Job:
RESIDENTIAL FLAT
BUILDING: - 1147, 1149
PACIFIC HWY & 2 BOBBIN
HEAD ROAD PYMBLE

BASEMENT LEVEL 1

SK04A

Job:
**RESIDENTIAL FLAT
BUILDING - 1147, 1149
PACIFIC HWY & 2 BOBBIN
HEAD ROAD PYMBLE**
Drawing title:
ELEVATIONS

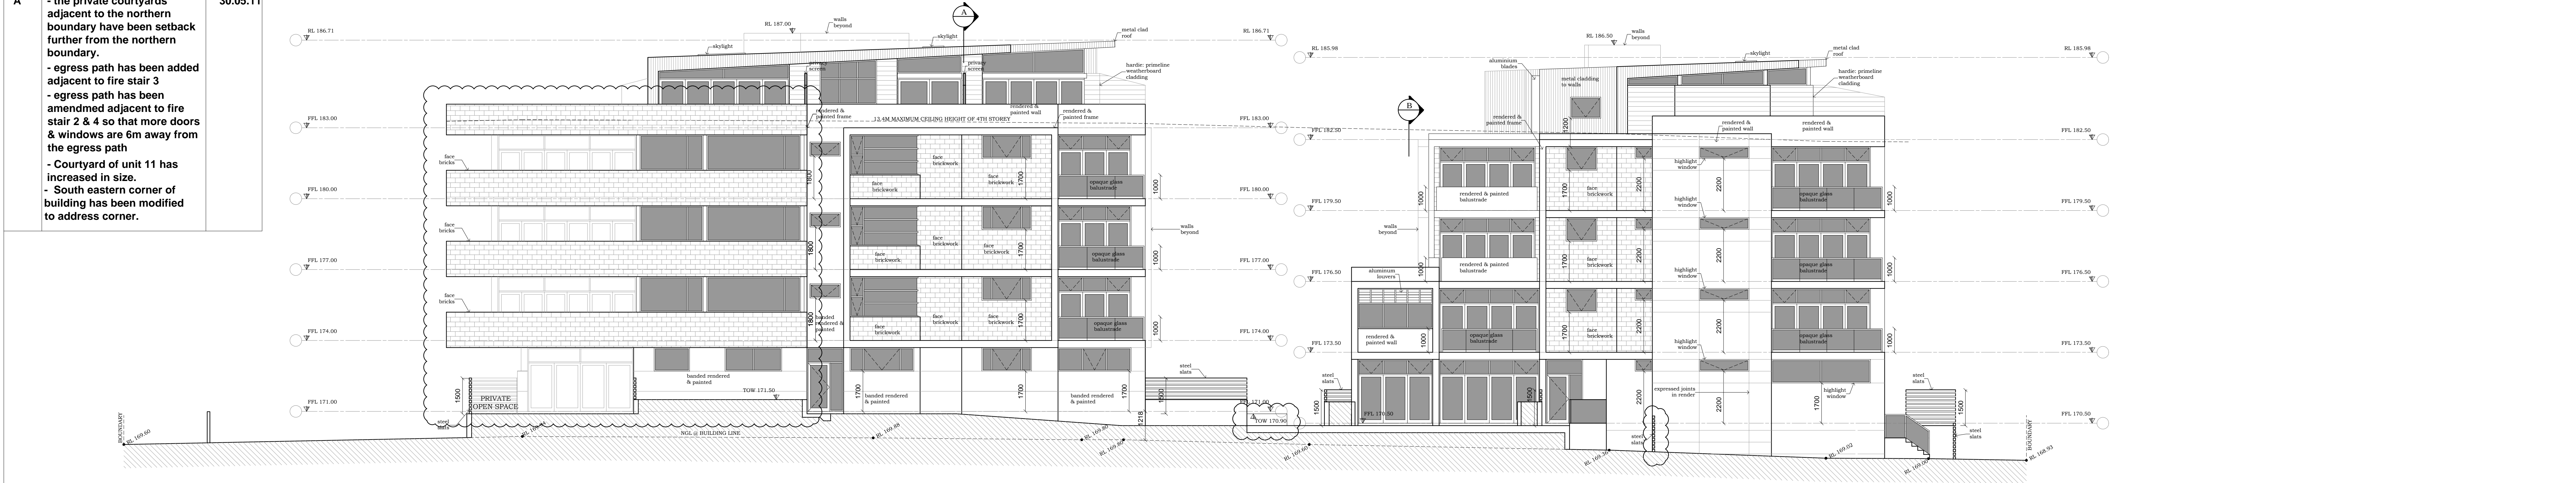
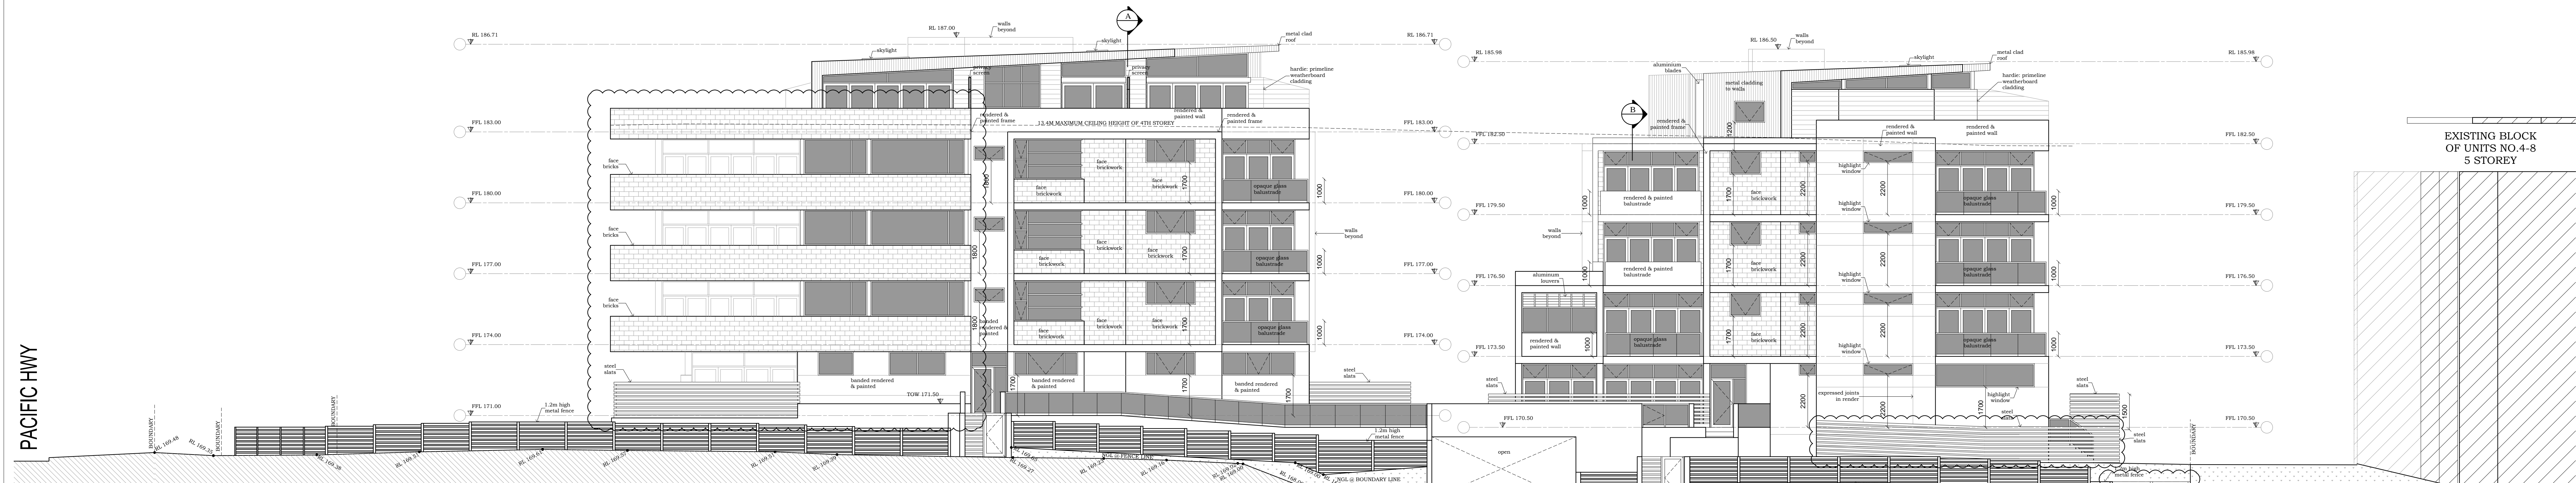
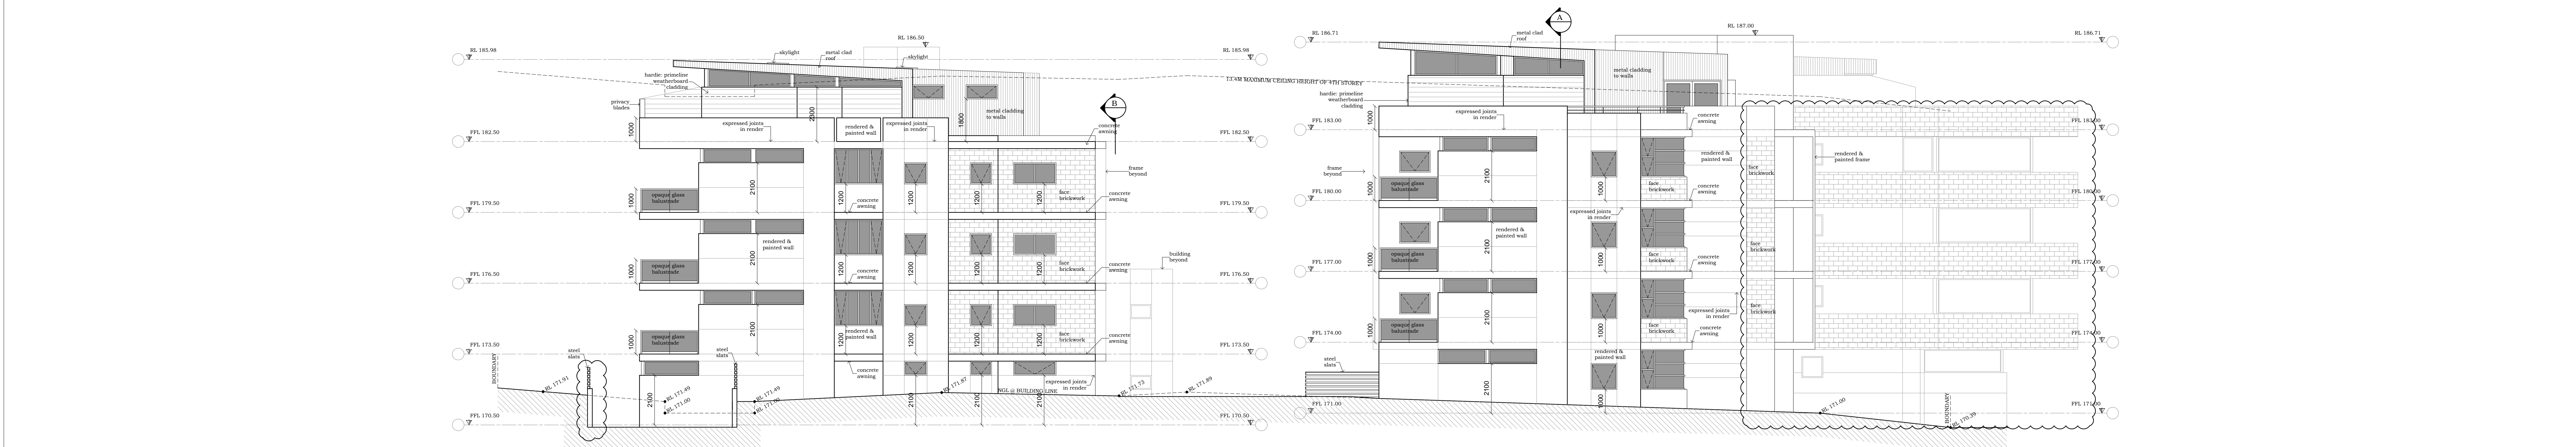
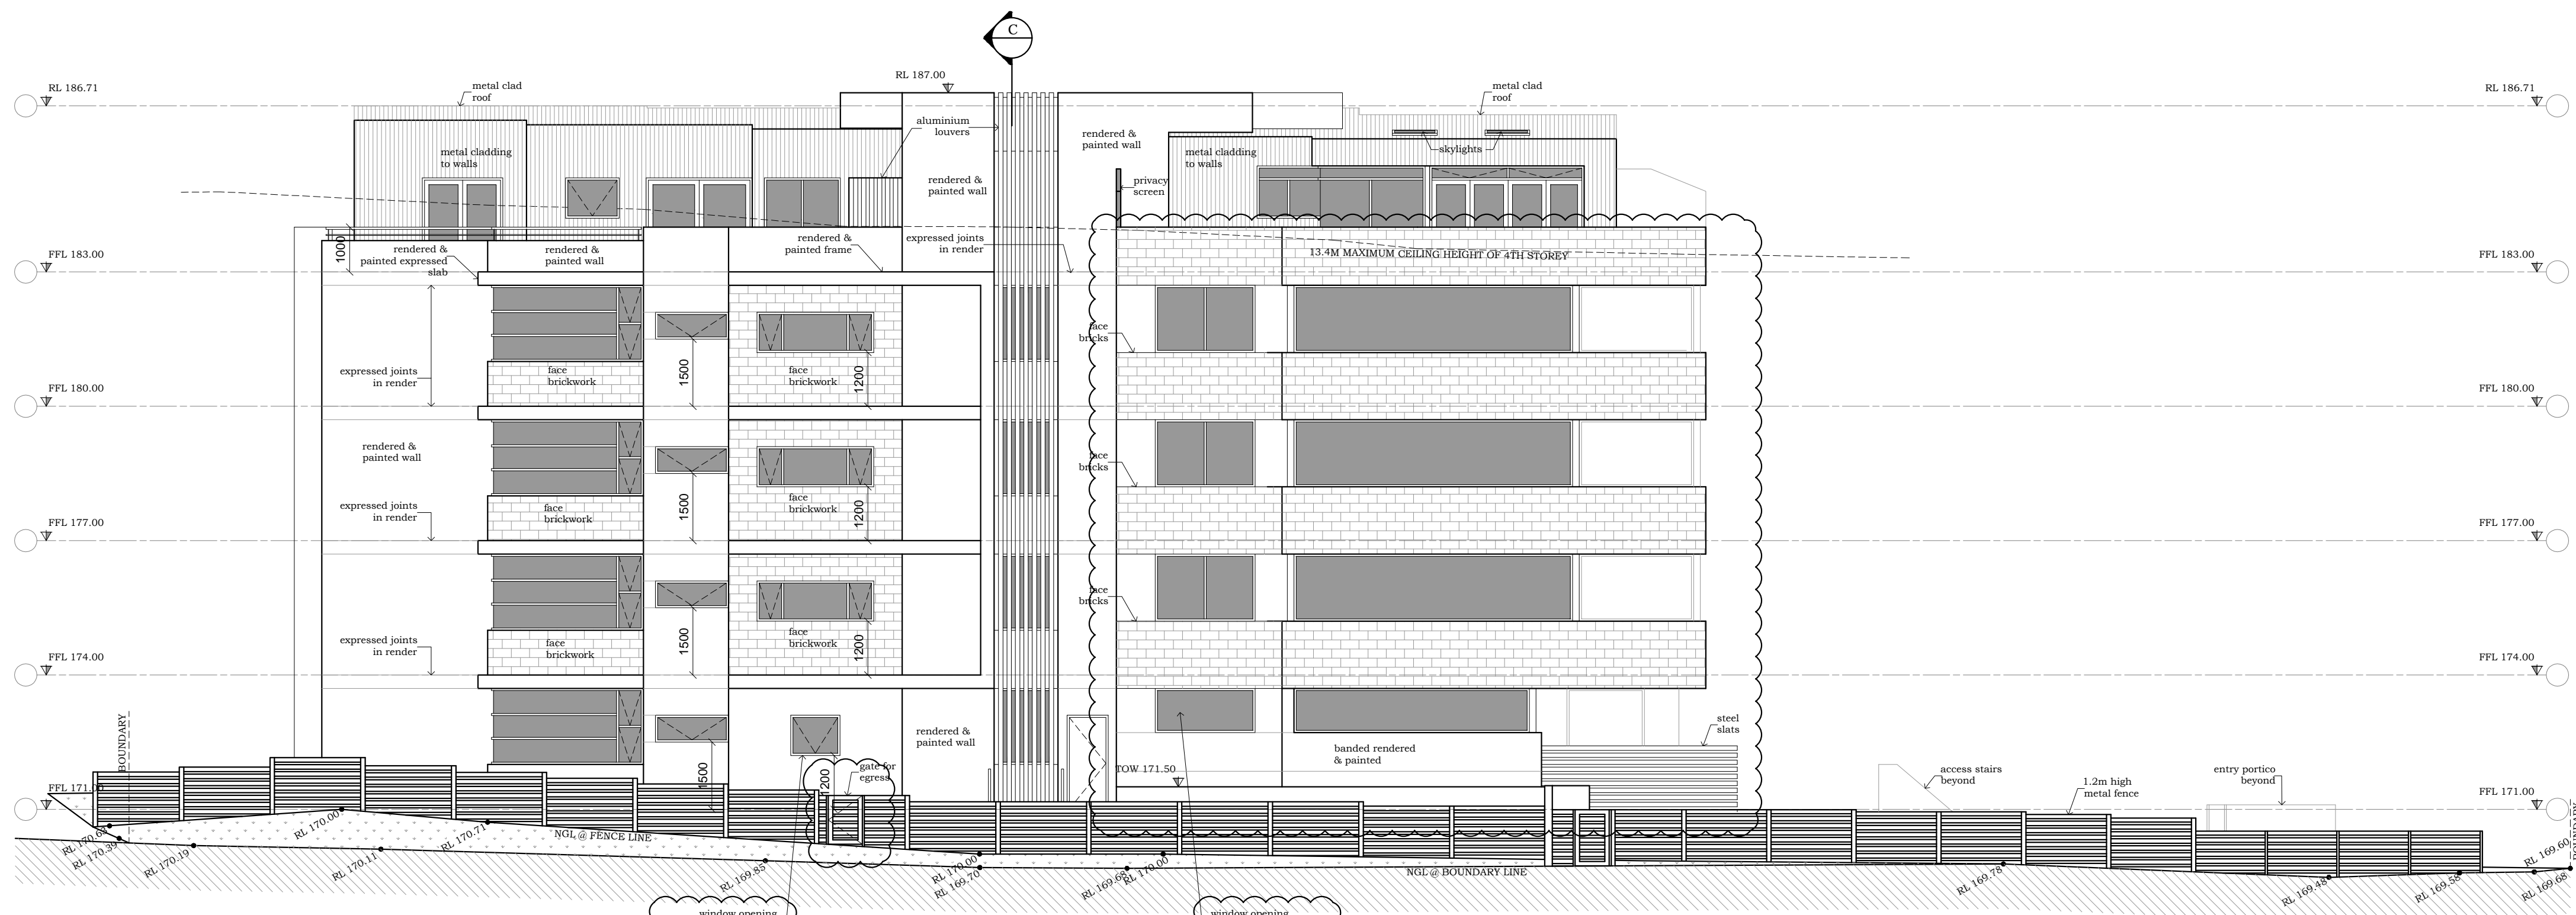
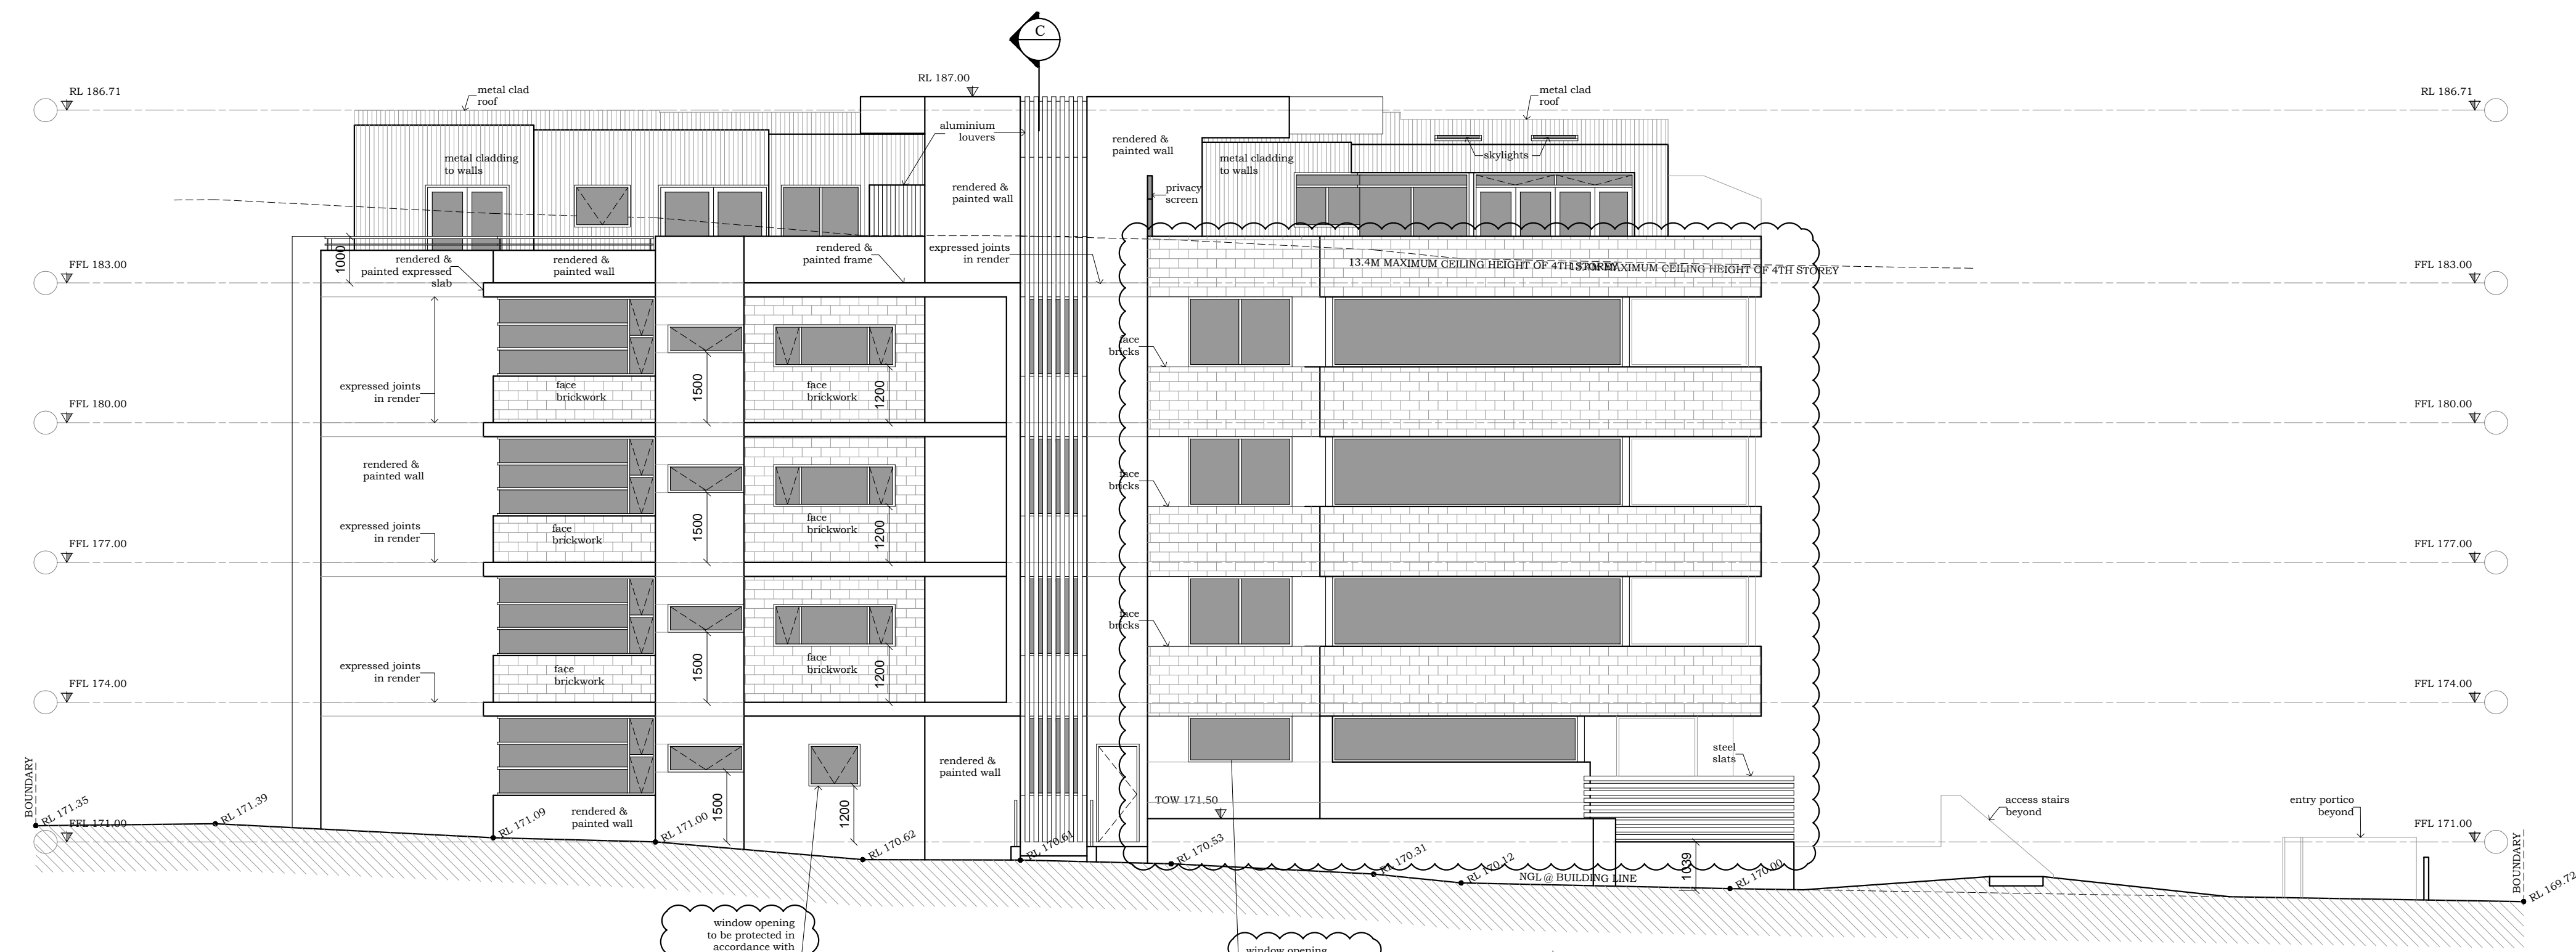
REV	AMENDMENTS	DATE
A	<ul style="list-style-type: none">- the private courtyards adjacent to the northern boundary have been setback further from the northern boundary.- egress path has been added adjacent to fire stair 3- egress path has been amended adjacent to fire stair 2 & 4 so that more doors & windows are 6m away from the egress path- Courtyard of unit 11 has increased in size.- South eastern corner of building has been modified to address corner.	30.05.11
